Access Compliance Report

Public Rights-of-Way

(Curb Ramps)

Intersection ID: 30004	Main Street: DAY_LILLY_LN	Cross Street: MANDY_PLACE_CT	Location: NE
ADA ID: 9E830C88FE5E	Ramp Type: PerpDiag	Initial Pass/Fail: Fail	Overall Compliance: No
Severity Score: 33.75			
Codes/Mitigation Info/Possible Solution		Field Measurements/Component Compliance

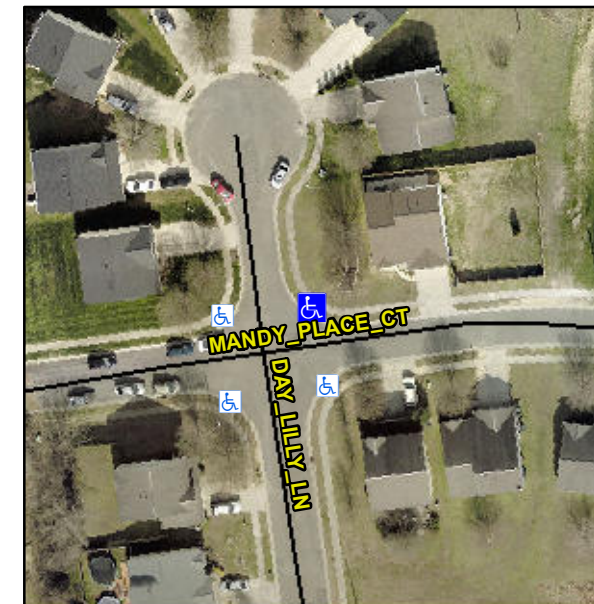
Not Found, R304.5.1, R304.2.2, R304.5.3

Compliance	Description	Data	Compliance	Description	Data
N/A	Ramp Length (in)	46.5	No	Ramp Slope (%)	9.2
No	Ramp Width (in)	42.5	No	Ramp XSlope (%)	6.2
N/A	Flare Type LT	N/A	N/A	Flare Type RT	N/A
N/A	Flare Slope LT (%)	N/A	N/A	Flare Slope RT (%)	N/A
N/A	Flare Traversable LT?	N/A	N/A	Flare Traversable RT?	N/A
N/A	Landing Length (in)	N/A	N/A	DWS Provided?	N/A
N/A	Landing Width (in)	N/A	N/A	DWS Contrast?	N/A
N/A	Landing Slope (%)	N/A	N/A	DWS Length (in)	N/A
N/A	Landing X Slope (%)	N/A	N/A	DWS Full Width?	N/A
N/A	Landing Curb? (Y/N)	N/A	N/A	DWS Offset (in)	N/A
N/A	Shared Landing?	N/A			
N/A	Gutter Ponding?	N/A	N/A	Gutter Slope (%)	N/A
N/A	Gutter Lip Ht (in)	N/A	N/A	Gutter X Slope (%)	N/A
N/A	Painted X Walk1?	No	N/A	Painted X Walk2?	No
	X Walk 1 Direction	To W		X Walk 2 Direction	To S
N/A	X Walk 1 Width (in)	N/A	N/A	X Walk 2 Width (in)	N/A
	X Walk 1 Slope (%)	2.5		X Walk 2 Slope (%)	5.7
	X Walk 1 X Slope (%)	5.3		X Walk 2 X Slope (%)	2.0

Remove & Replace Curb Ramp With Two New Directional Ramps or Equivalent.
